## ADDENDUM NO. 1

Board of Education – New Parking Lot

San Bernardino City Unified School District

RCA Project No. 1-78-60

C-1.0

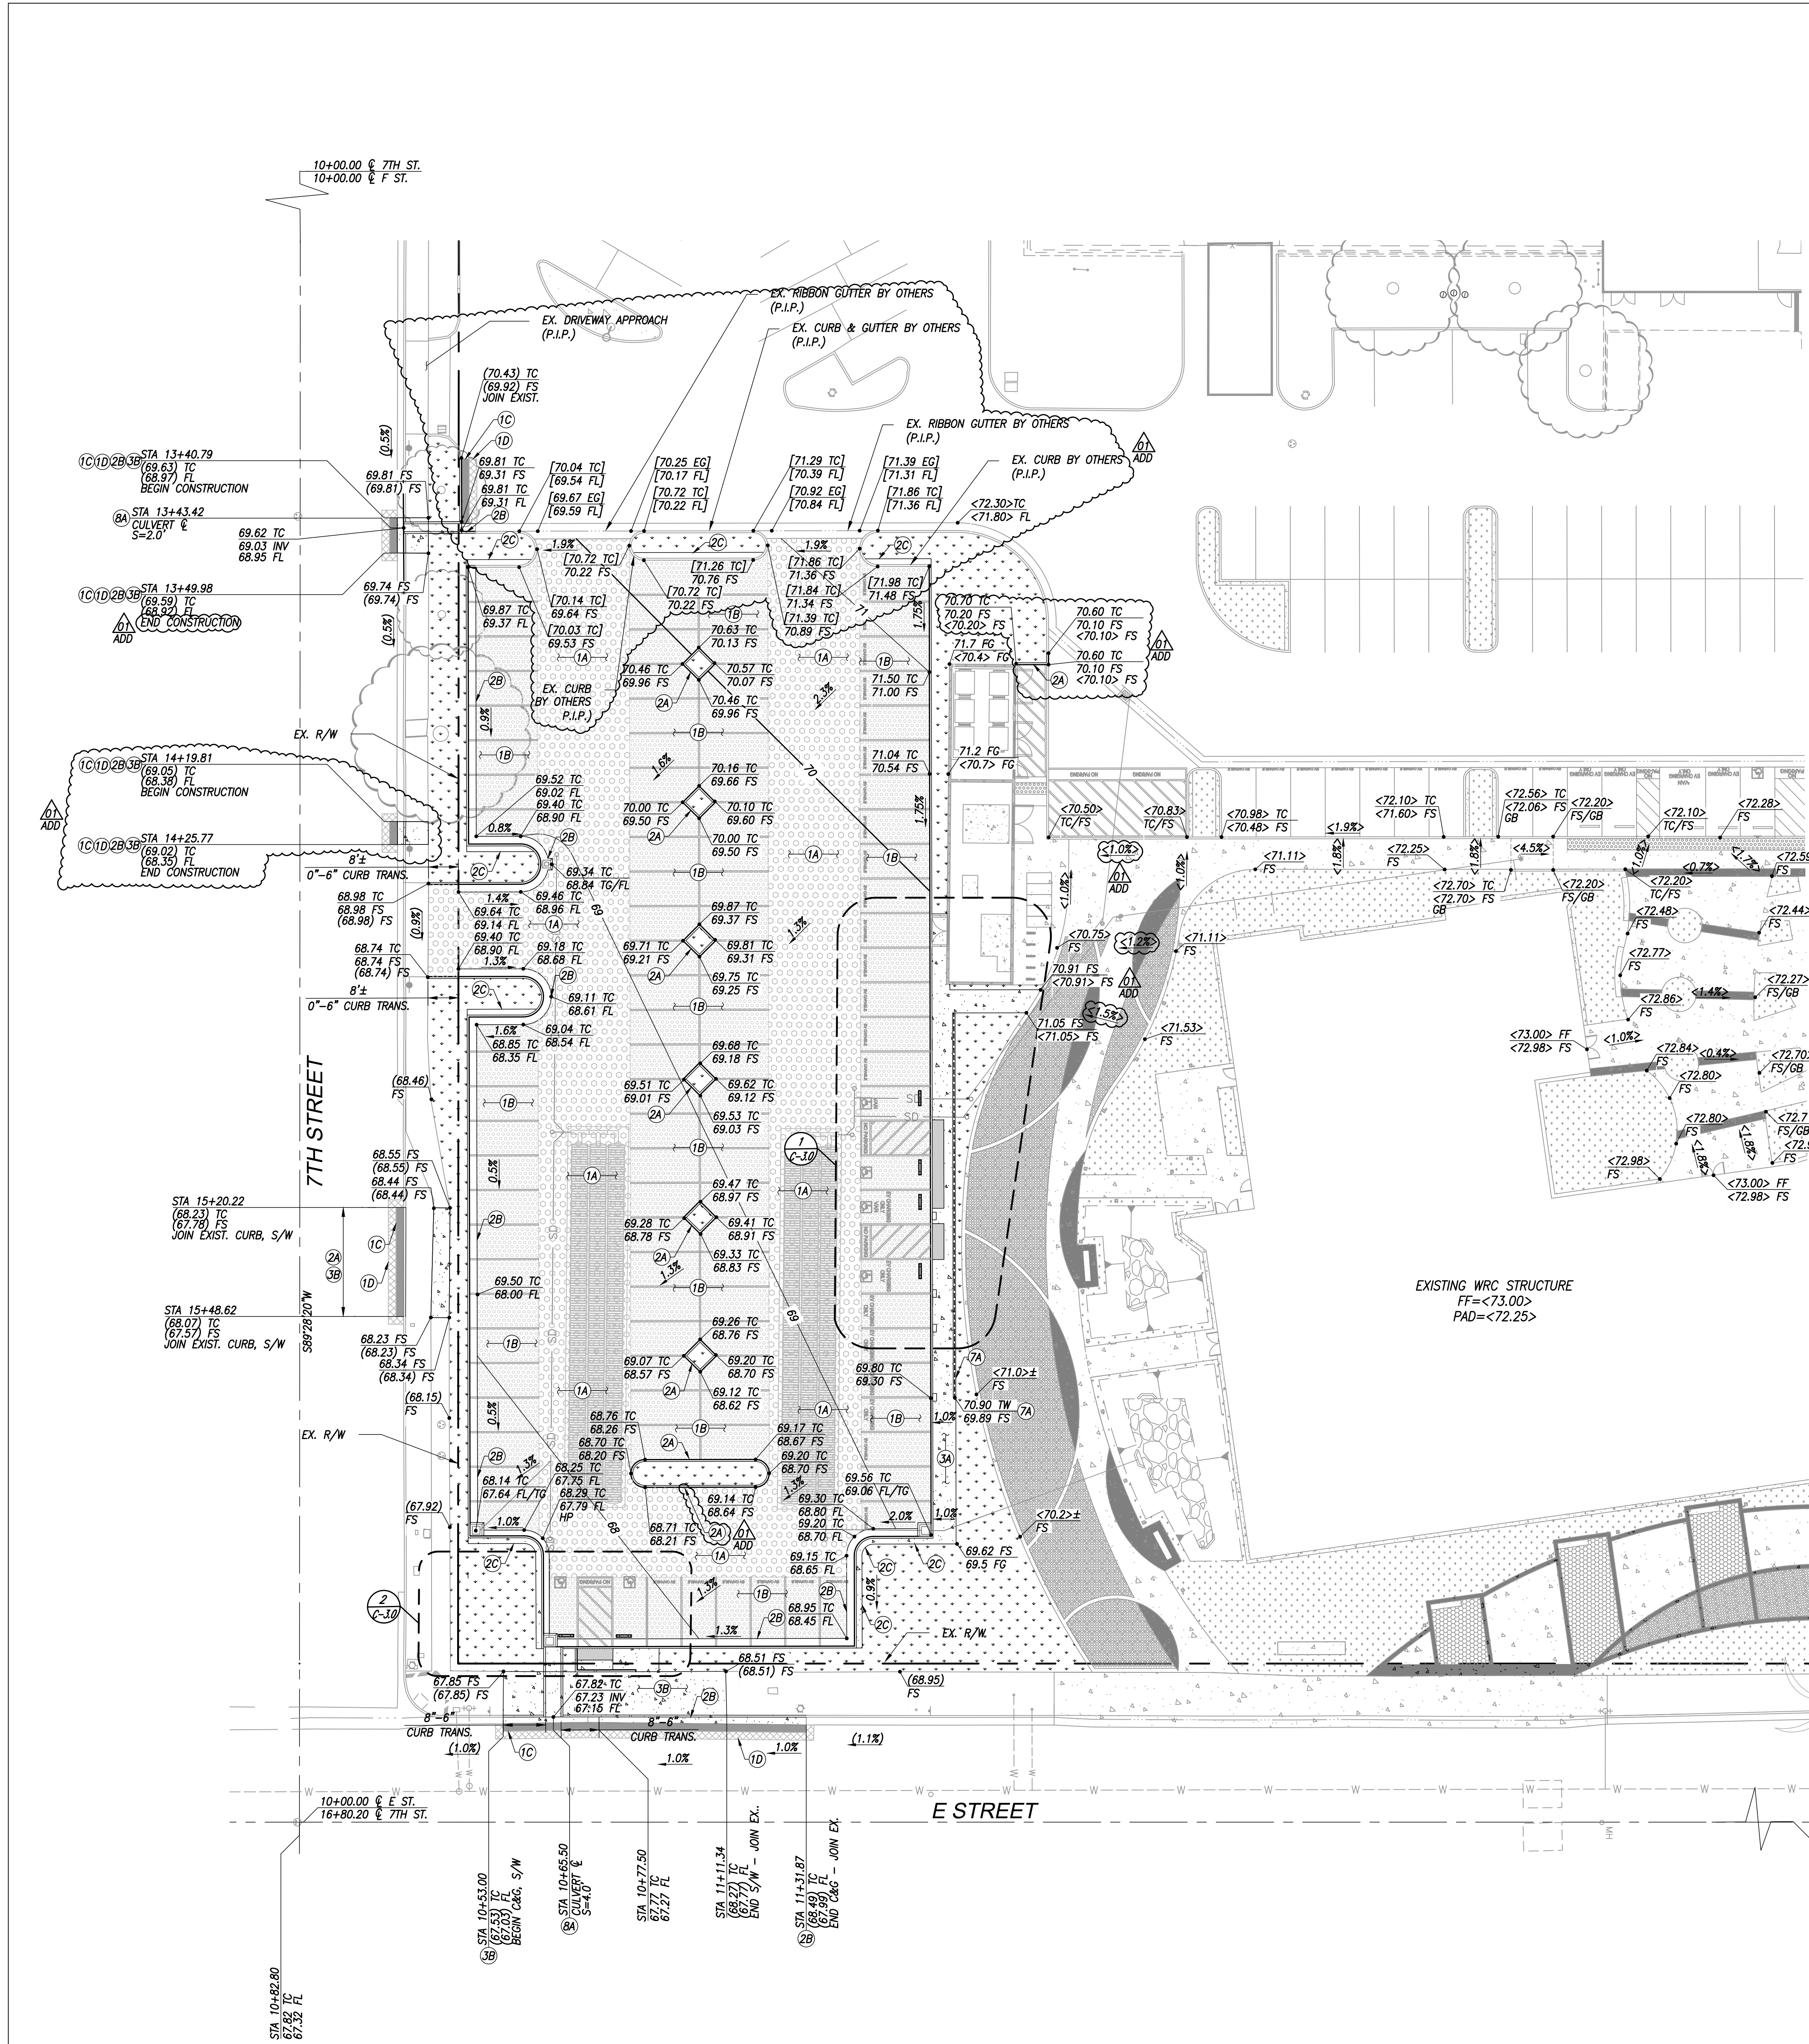
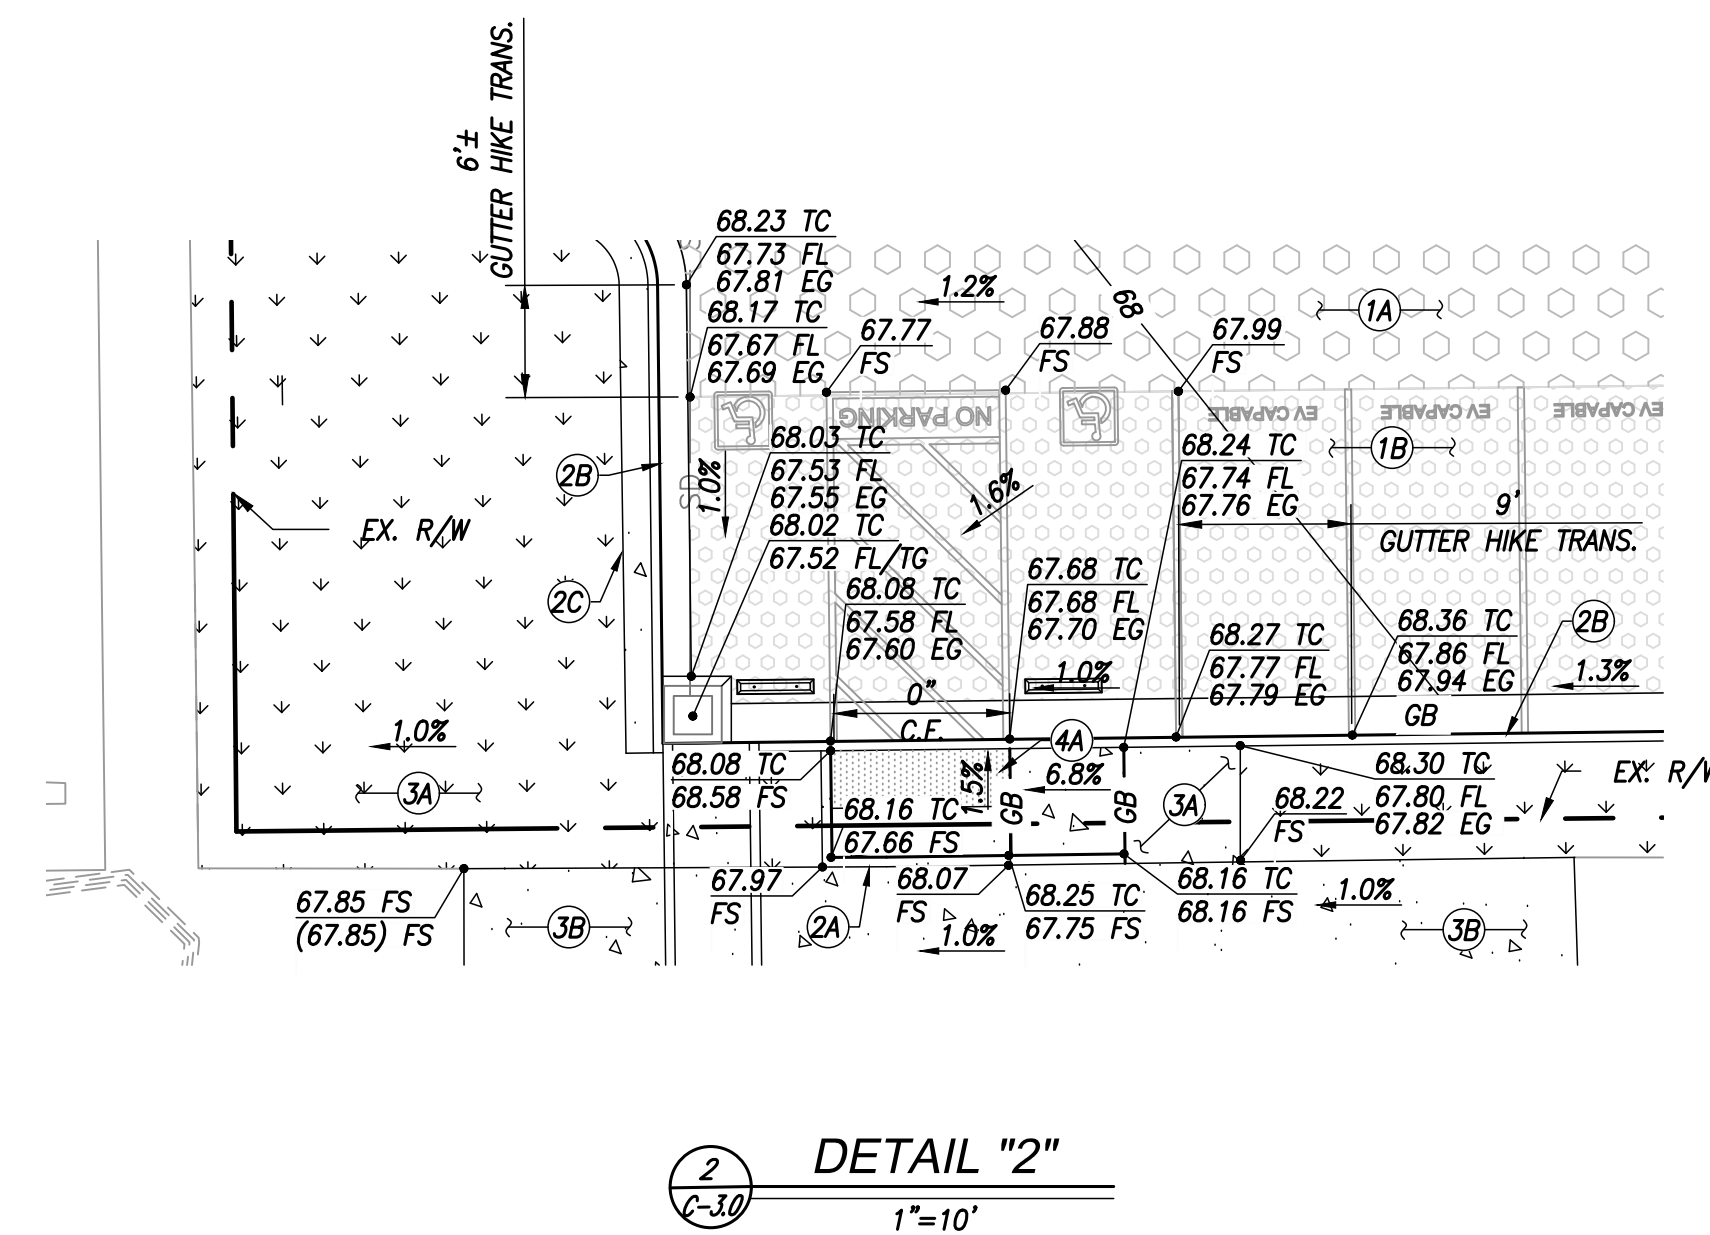
- Item No. 1.2      Reference Sheet C-1.0 – TITLE SHEET  
1.2.1      Replace Sheet C-1.0 and revise per clouded areas listed below:  
                    (a)    Added existing spot elevations to legend.
